6623A-16

S E R V I C E N O T E

6623A DC Power Supply

Intermittent Power Transformer “Magma” Connections

Top View of Power Transformer:

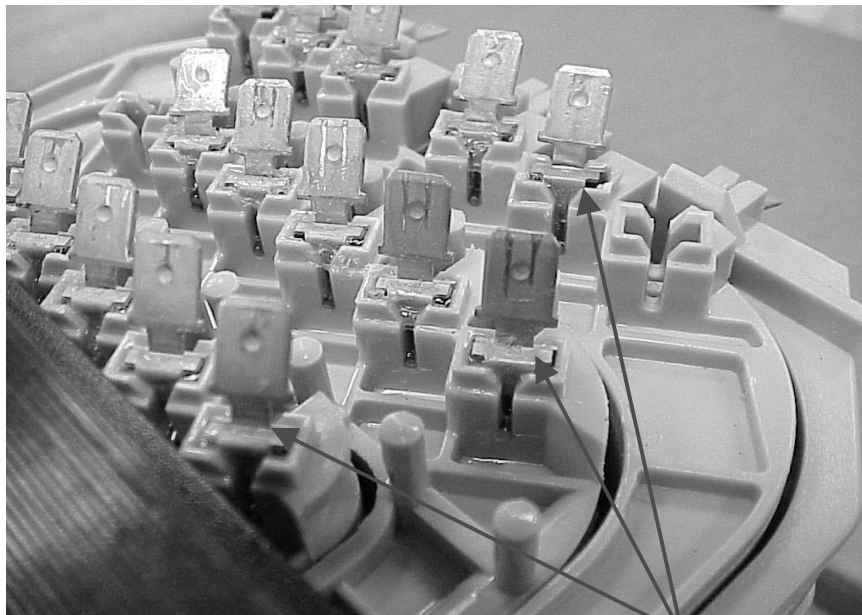
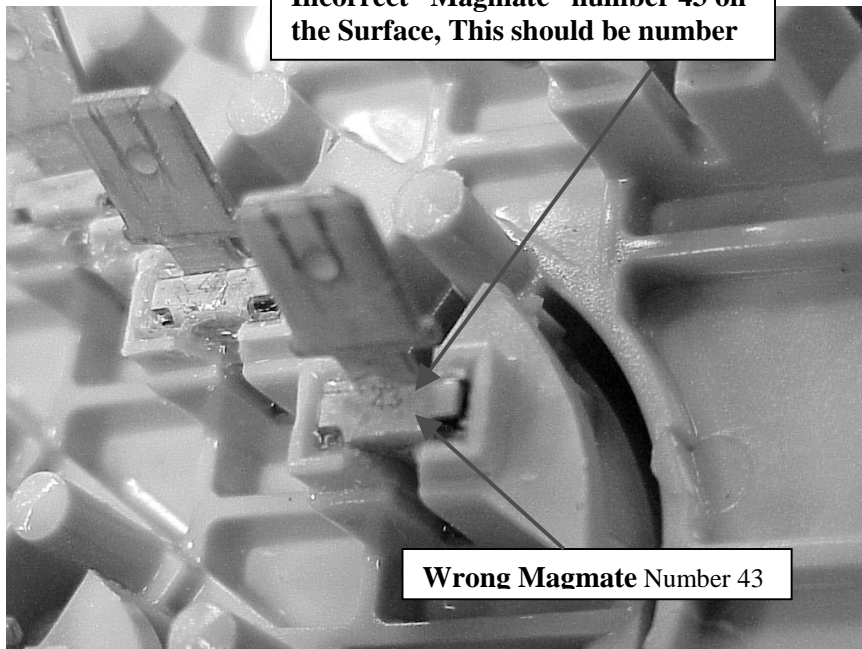
The power transformer vendor mistakenly installed the wrong “Magmates” in a run of power transformers. The incorrect “Magmates” have a # 43 stamped on them, which corresponds to a 15 gauge wire size. The correct size “Magmate” should be # 24 designed for a 19 gauge wire size.

Incorrect “Magmate” number 43 on the Surface, This should be number

Wrong Magmate Number 43

Replace the Power Transformer with a new replacement Transformer, see the table above for the correct power transformer part number.

NOTE: Please inspect the new transformer for the correct “Magmate” number stamping.
